STAFF REPORT
COMMUNITY DEVELOPMENT DEPARTMENT

HEARING DATE: 4/5/2022
TO: Mayor & City Council
FROM: Alan Tiefenbach, Associate Planner
208-489-0573
SUBJECT: FP-2021-0058
Skybreak No. 1
LOCATION: 7020 S. Eagle Rd. & 3487 E. Adler Hof Ln., in the south ½ of the NW ¼ of Section 4, T.2N., R.1E. (Parcels # S1404244250 & S1404233650)

Final plat consisting of 84 lots and 21 common lots on 35.67 acres of land in the R-8 and R-15 zoning districts.

C. Graphic on narrative included with DA indicating area of no-build (date: 6/14/2021)

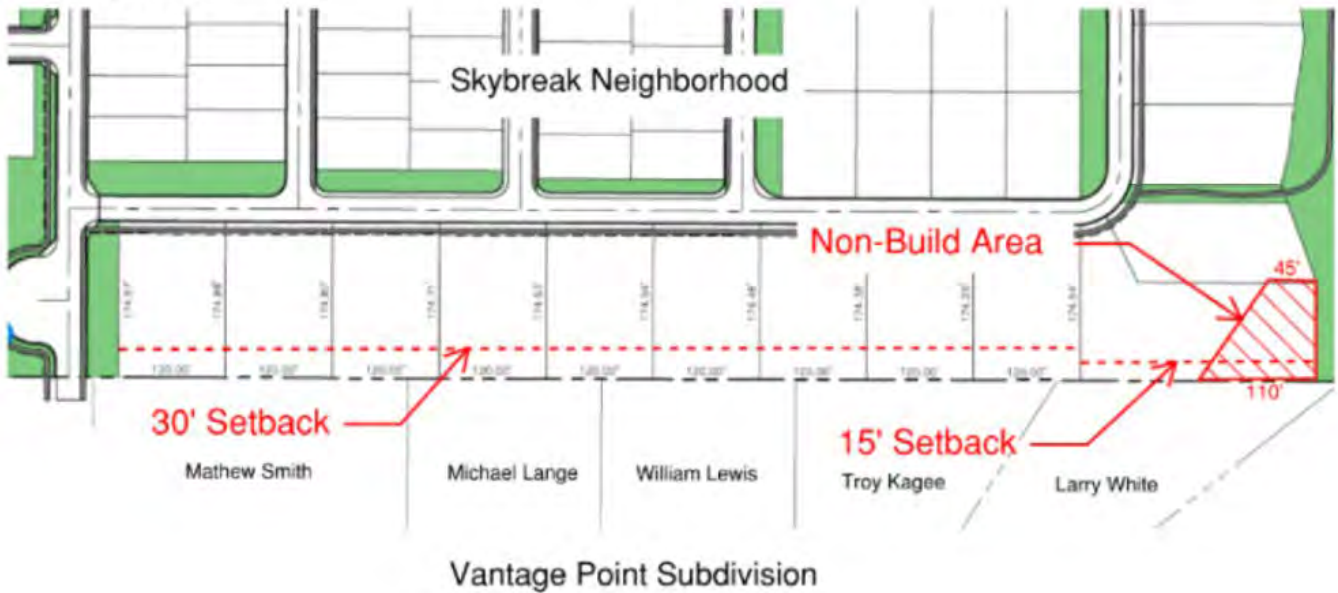
Another condition of approval of the development agreement required an increased rear setback (as shown in applicant' s narrative as a “no-build area” dated June 14, 2021) for Lot 74, Block 5, abutting

Vantage Pointe (now Lot 36, Block 3). This no build area is not indicated on the final plat. Staff has added this as a condition of approval.

- a. A 15 ft. side yard setback and no build area (as shown in Exhibit V.B) shall be indicated on the plat for Lot 36, Block 3, abutting Vantage Pointe.

- b. A 30 ft. rear yard setback (as shown in Exhibit V.B) shall be indicated on the plat along Lots 36-45, Block 3.
 - c. Plat Note No. 5 – add instrument number.

C. Landscape Plan (date: 11/17/2021)

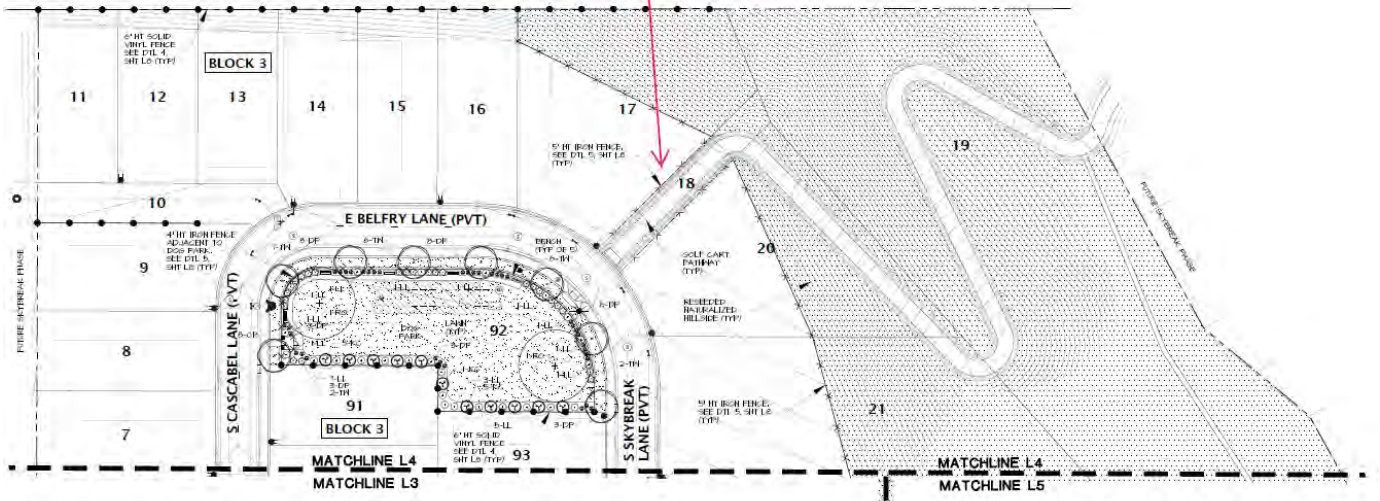
Staff notes although the applicant did receive alternative compliance from UDC 11-3B-12 and UDC 11-3G-3 to allow the area surrounding the pathway along Lot 46, Block 5 to remain in a natural state (now indicated as Lot 19, Block 3), this was intended for the area surrounding the natural pathway shown bisecting Lot 19, Block 3 from north to south. This did not extend to the paved golf cart pathway shown in both Lot 18 and 19, Block 3, as the approved preliminary plat landscape plan does show trees along this pathway. Also, the approved preliminary plat and landscape plan indicates sidewalk extending south along Lot 46, Block 3 to the Vantage Pointe subdivision, whereas this is absent on the final plat. Finally, the common drive exhibit indicates a 5 ft. wide landscape strip adjacent to the solid fence as required per UDC11-6C-3C, but this landscape strip is not shown on the landscape plan.

- a. Sidewalk meeting the requirements of UDC 11-3A-17 shall be added within Lot 46, Block 3 as shown on the approved preliminary plat landscape plan.

- b. Trees meeting the requirements of UDC 11-3B-12 shall be provided along the golf cart path in Lots 18 and 19, Block 3 shown on the approved preliminary plat landscape plan.

- c. A landscape strip meeting the requirements of 11-6C-3D shall be provided on the south side of the common drive in Lot 10, Block 3.
 - d. The landscape plan shall indicate any existing trees on the subject property that are four-inch caliper or greater; or mitigate for the loss of such trees as set forth in UDC 11-3B-10C.

Same area from approved landscape plan

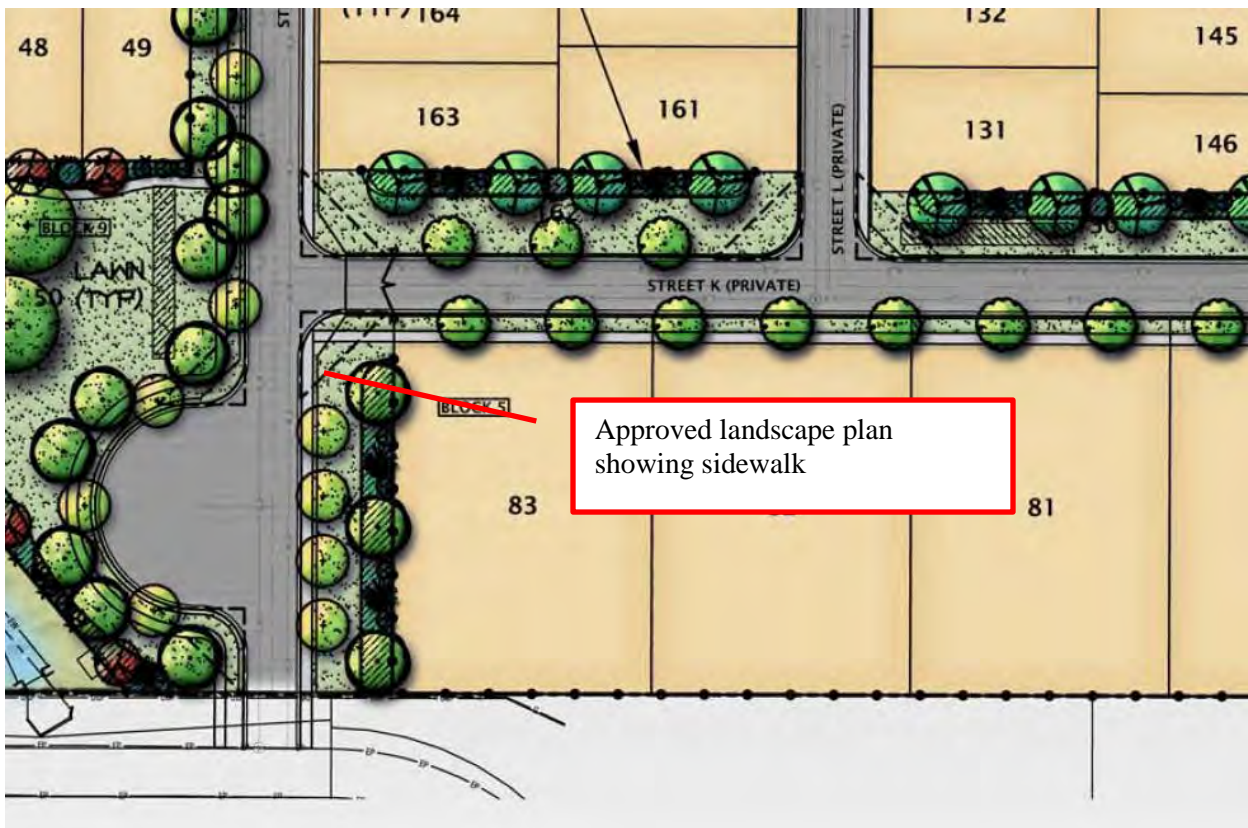
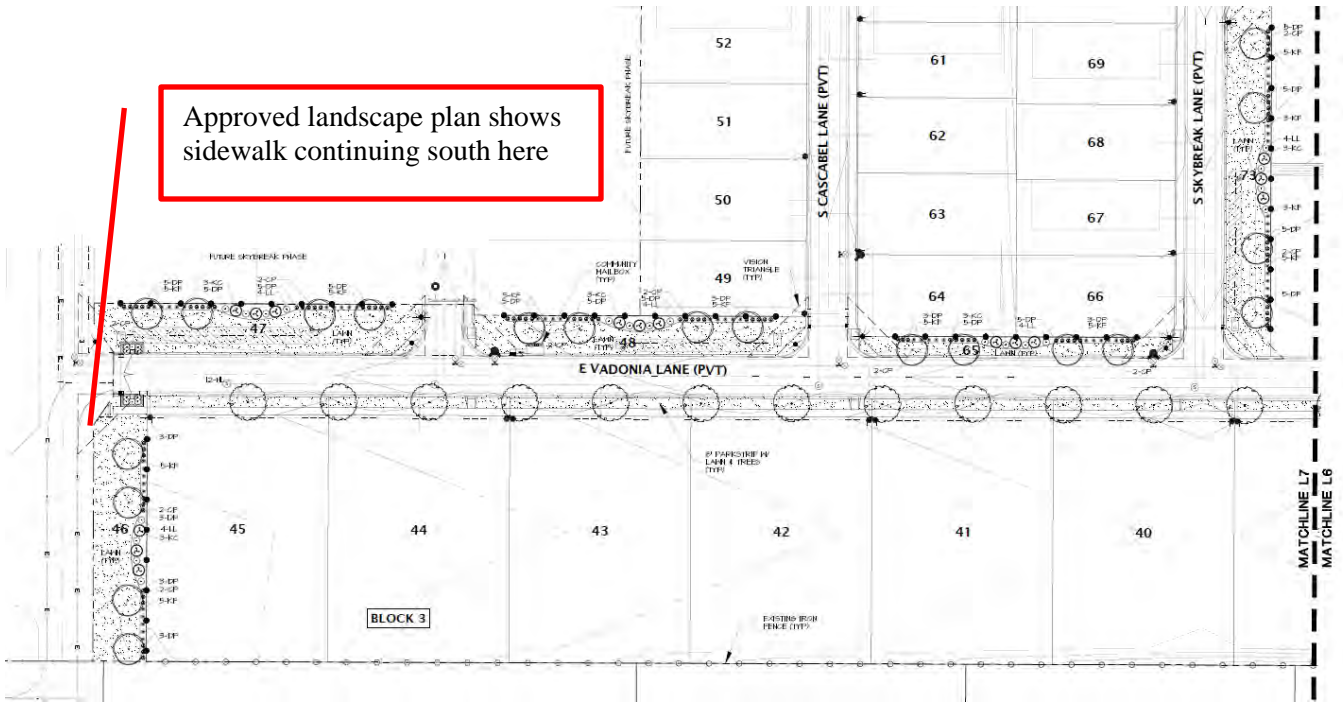
Approved landscape plan shows trees along this pathway
